SUBDIVISION REVIEW SHEET

CASE NO.: C8J-2021-0080.0A

SUBDIVISION NAME: Whisper Valley Multifamily Parcel 65 Preliminary Plan

CITY OF AUSTIN – TRAVIS COUNTY – SINGLE SUBDIVISION OFFICE SUBDIVISION APPLICATION – MASTER COMMENT REPORT

EXHIBIT B
C8J-2021-0066

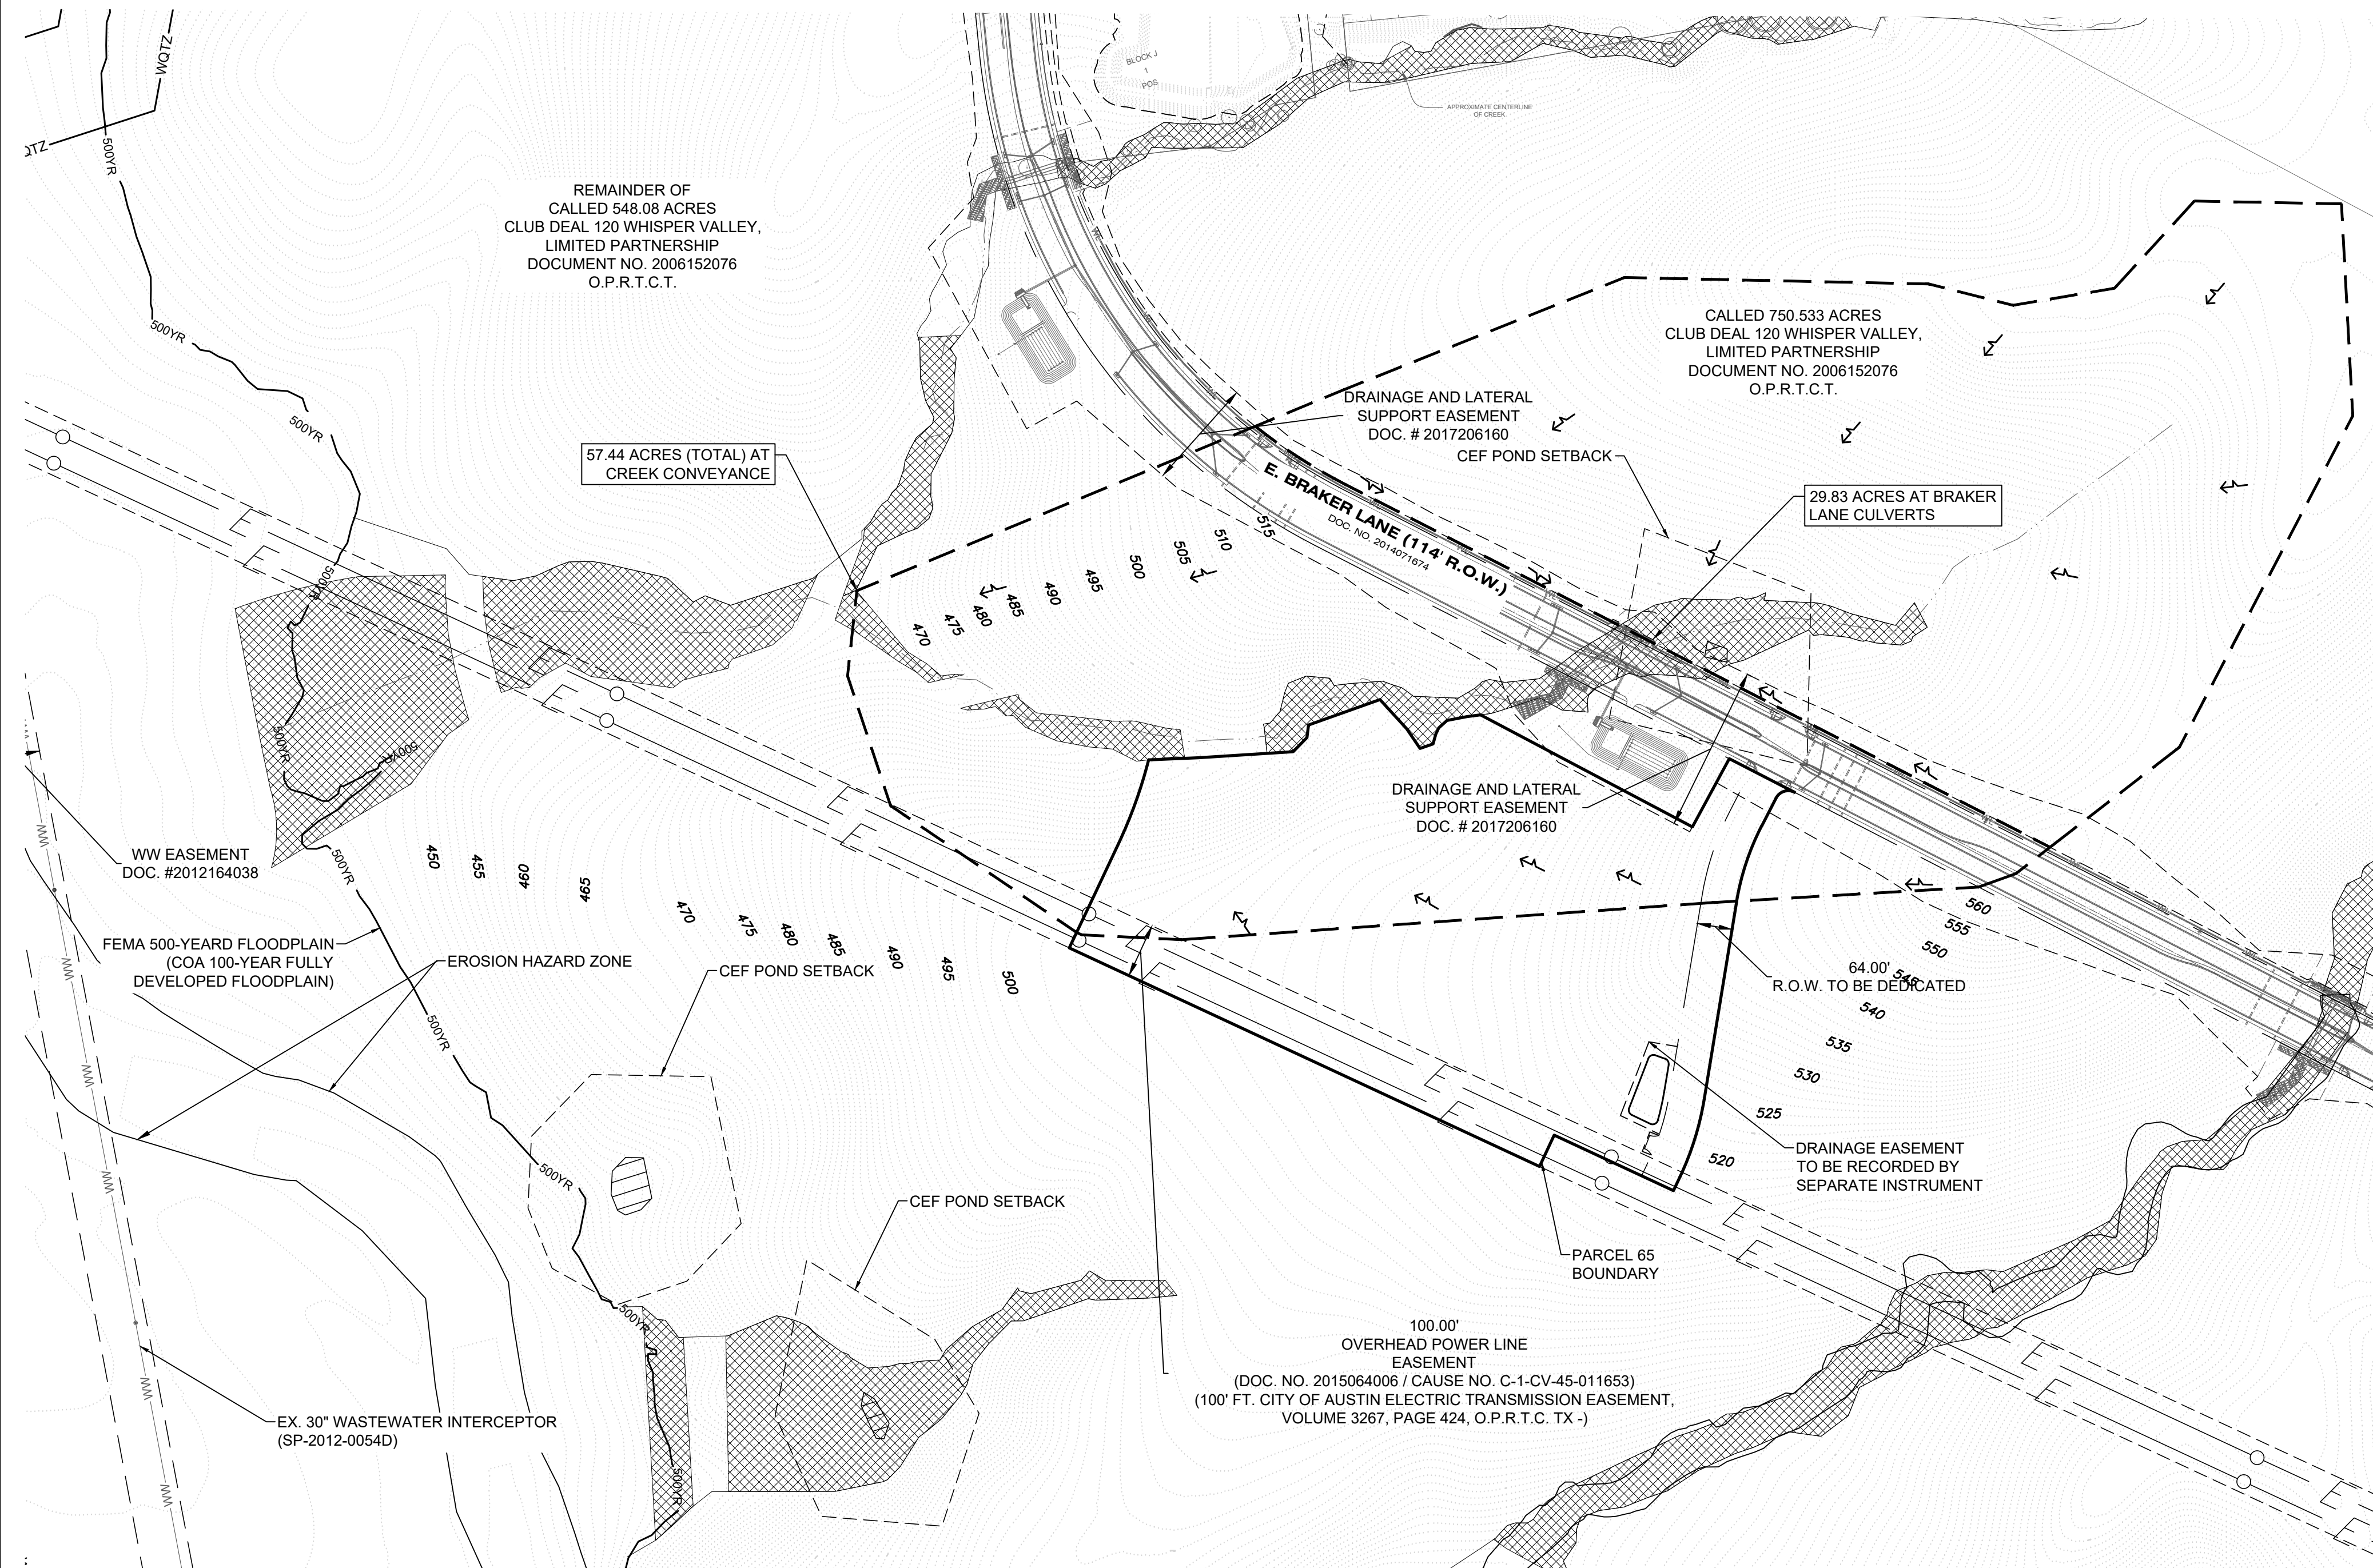
WQ3. Please clarify how runoff from Drainage Area P-1 is treated for water quality purposes. [LDC 30-5-211; ECM 1.9.2]

- DC 1. On Exhibit B in the Engineering Report I understand where POI 2 would be located, however I did not find it identified on the map; please include the designation and location for POI 2 for comparison with existing conditions peak flows at this location.
- DC 2. It isn't clear where detention will be provided for the increased runoff related to Lilt Drive; mitigation for increases in peak stormwater runoff will need to be provided with the construction plans for this final plat. Please clarify.

EXHIBIT F

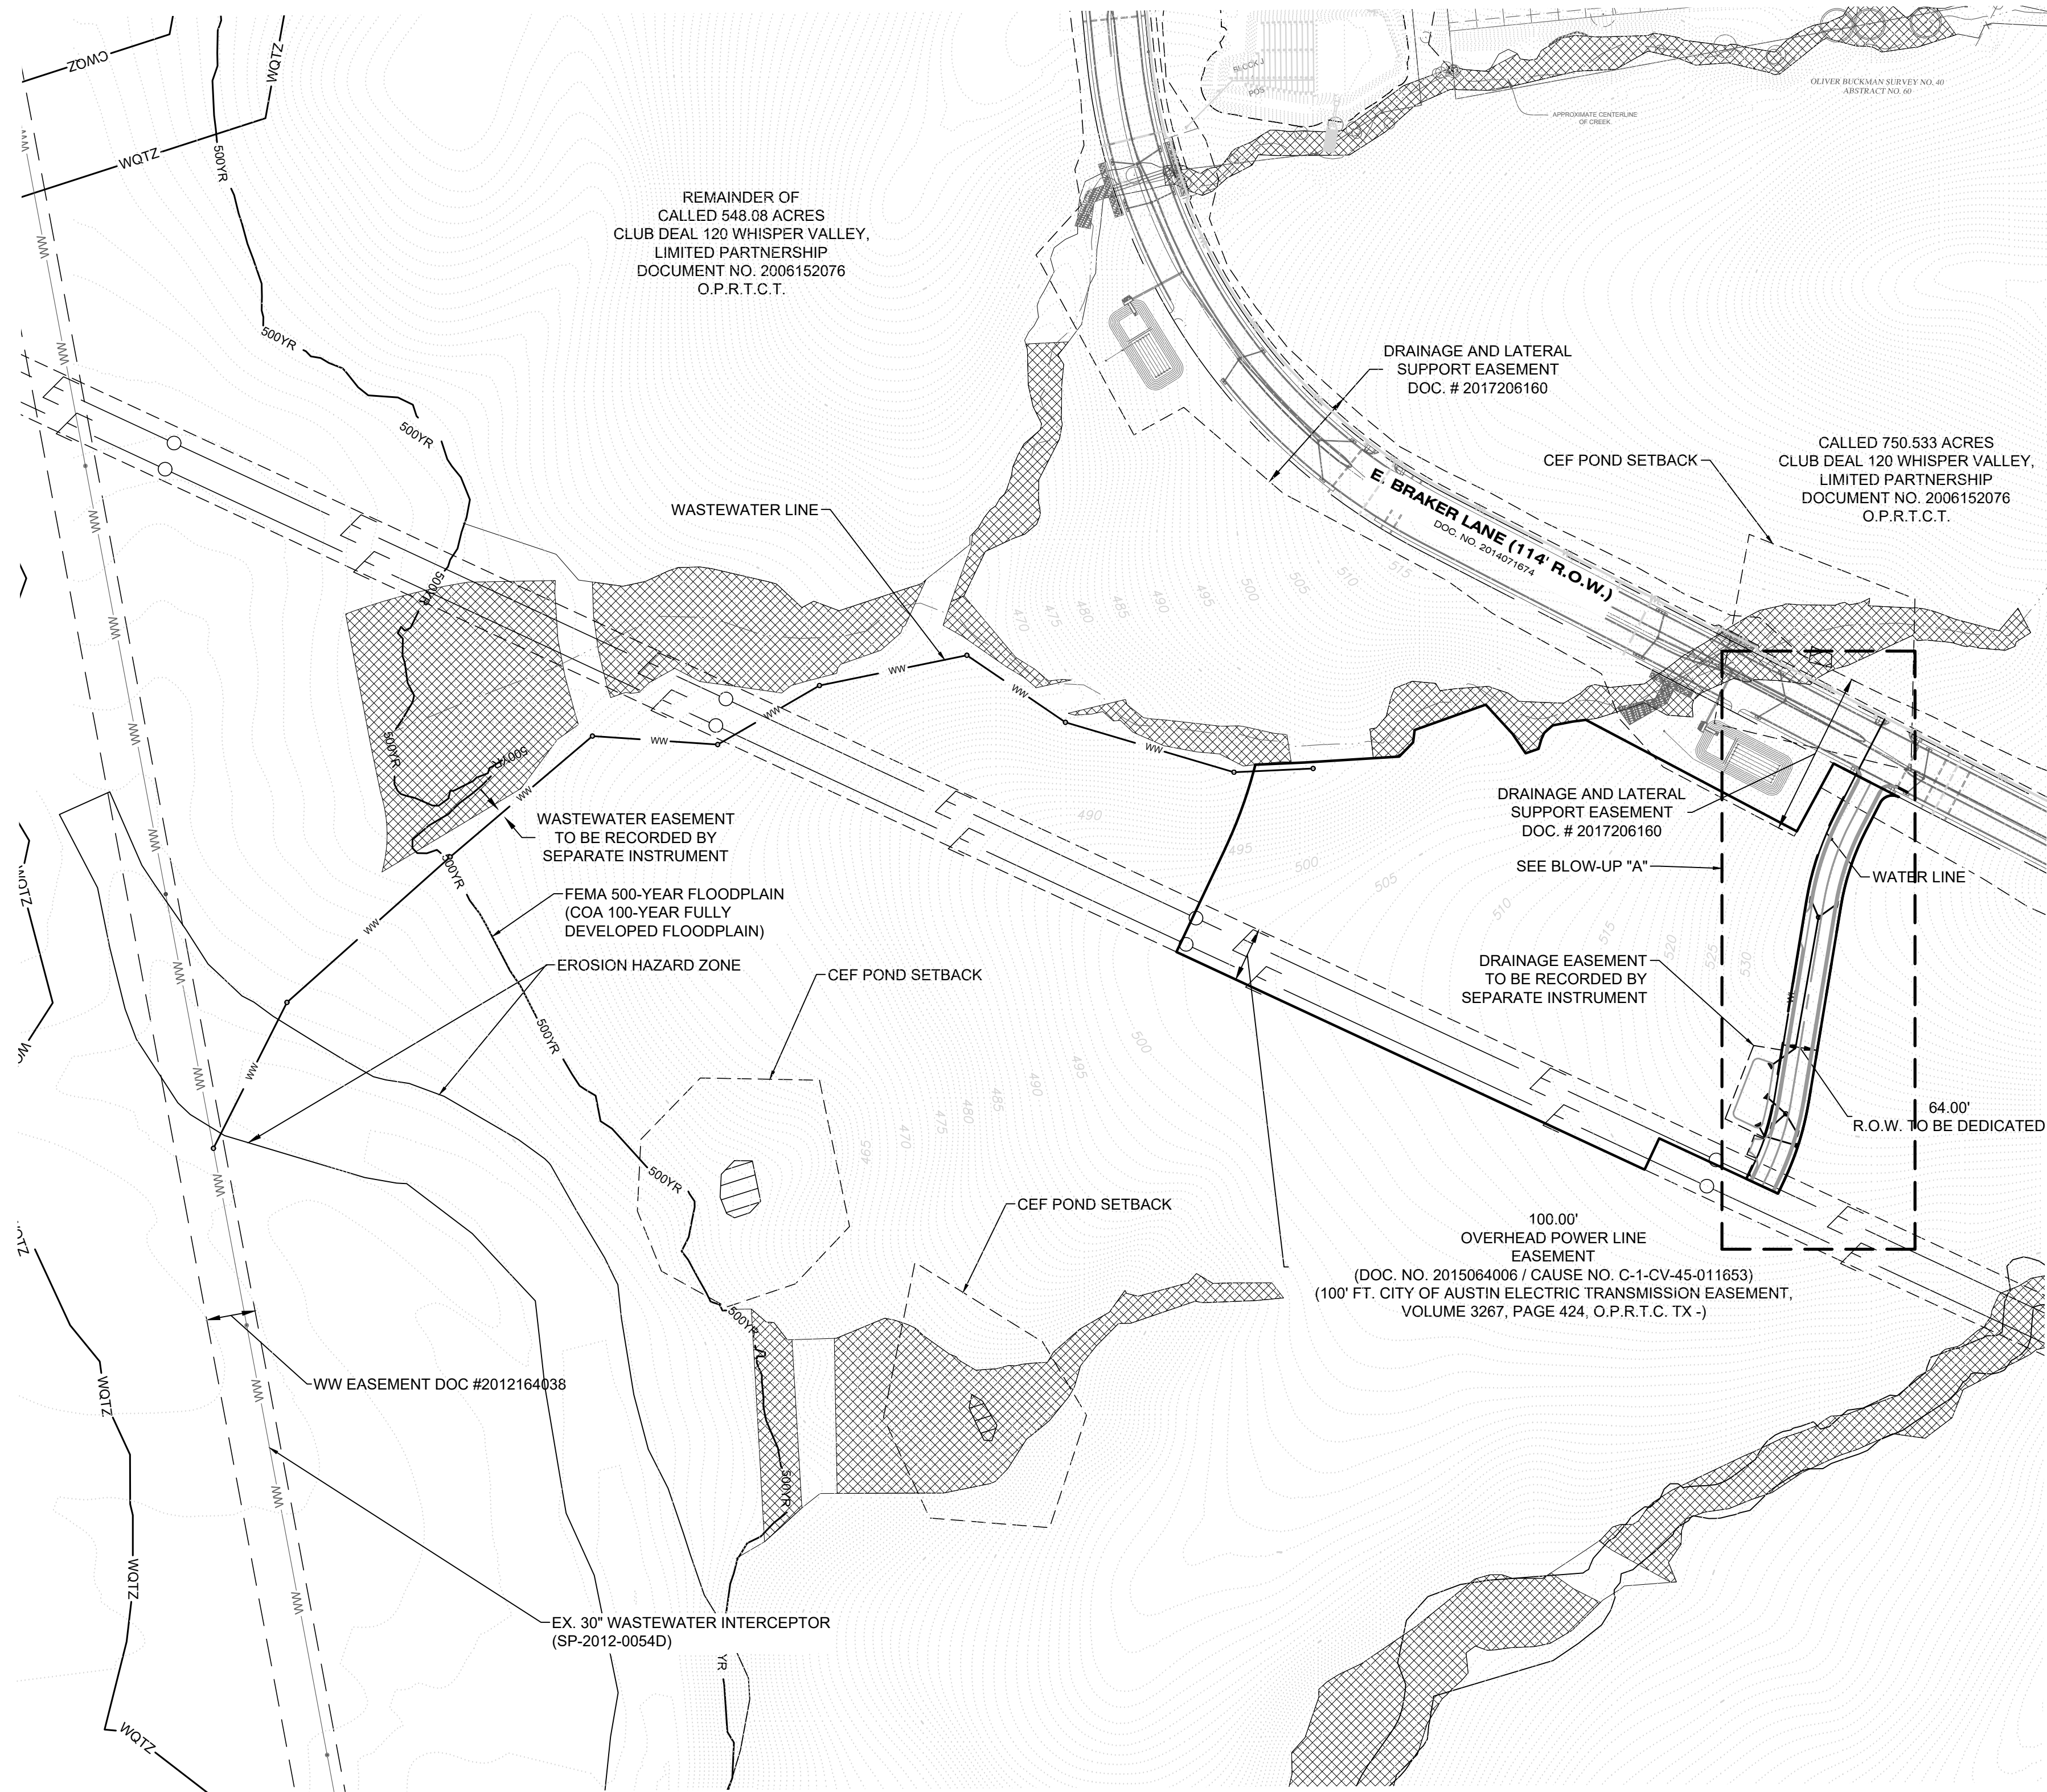
- CA1 More information is required to give specific feedback related to tree regulations. Provide the following tree information:
Tree Survey (plan) to include:

- CA2 Removal of heritage trees is not allowed by code. Demonstrate compliance with LDC 25-8-641. Provide conceptual buildability exhibits for all lots with heritage trees. Include existing regulated trees shown with conceptual footprints, driveway, proposed grading, and all utilities required to serve each lot.
